# City of Alexandria, Virginia

## MEMORANDUM

**SUBJECT:** STRAWBERRY RUN STREAM RESTORATION PROJECT  
RESPONSE TO MARCH 13, 2021 PUBLIC COMMENTS

# Strawberry Run Stream Restoration Location Map

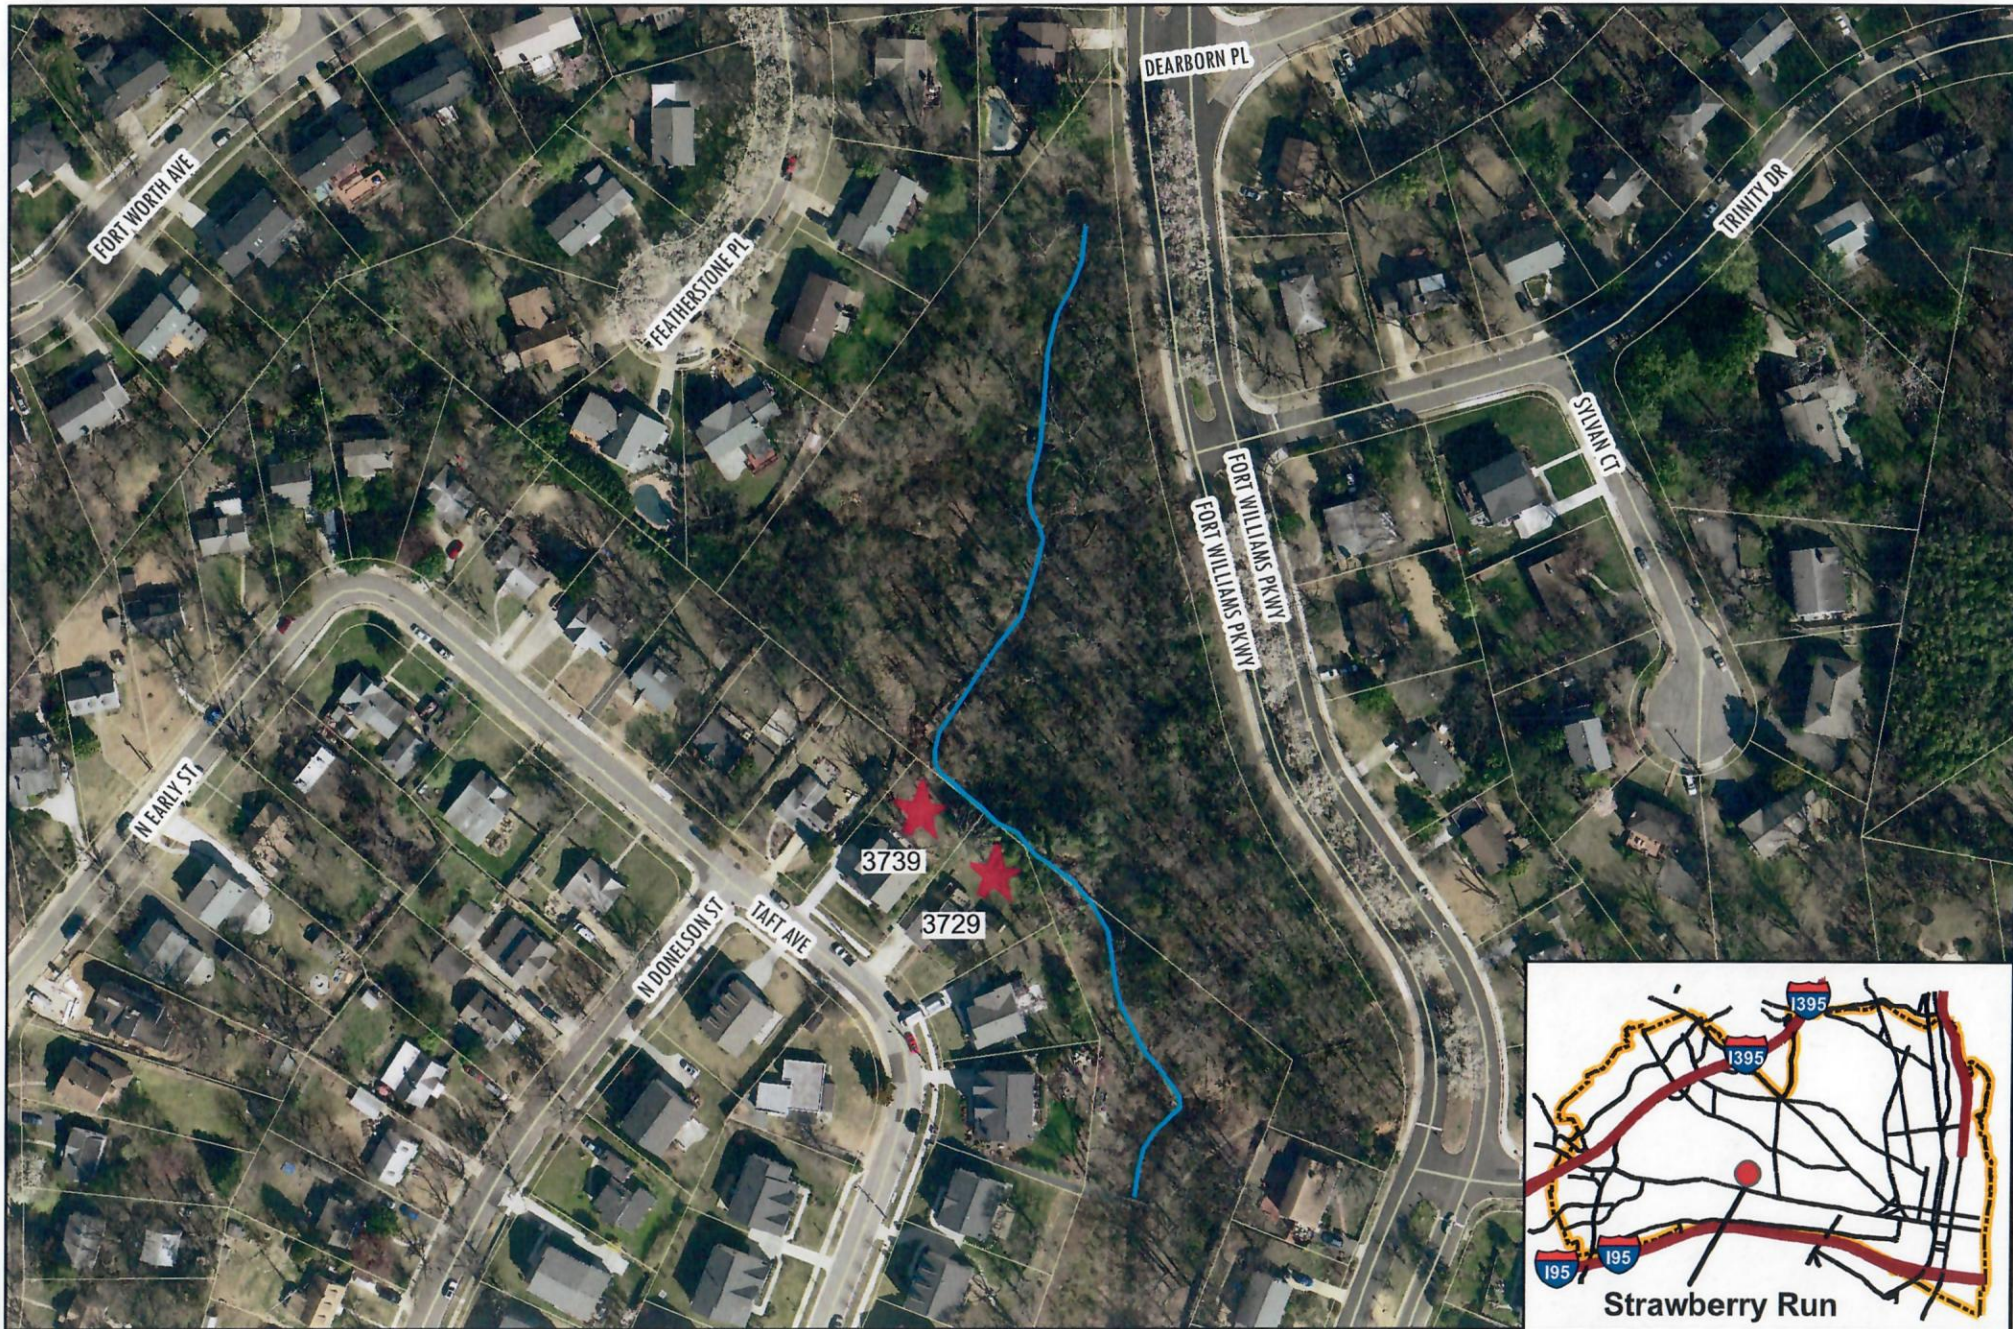
With respect to the first sentence, ten property owners immediately adjacent to the potential projects in the nine locations where projects were under consideration were sent field notification letters dated February 26, 2018 prior to the start of field work for these five potential stream restorations projects and four potential outfall rehabilitation locations as part of the Phase III Stream Assessment<sup>2</sup> to consider and rank potential projects. TES staff defines “immediately adjacent” as those properties abutting or likely within the potential project area. Therefore, nearby property owners whose property do not abut the stream were not sent letters. Our records indicate that letters (Attachment 2) were sent to 3729 and 3739 Taft Avenue to notify upcoming “field reconnaissance on or near your property to assess the conditions of streams and/or outfalls” prior to conducting onsite analysis for Strawberry Run. Issuance of field notification letters is typical when considering projects like this. Attachment 1 is provided which shows the Strawberry Run project location depicting the immediate adjacency of 3729 and 3739 Taft Avenue to the proposed project.
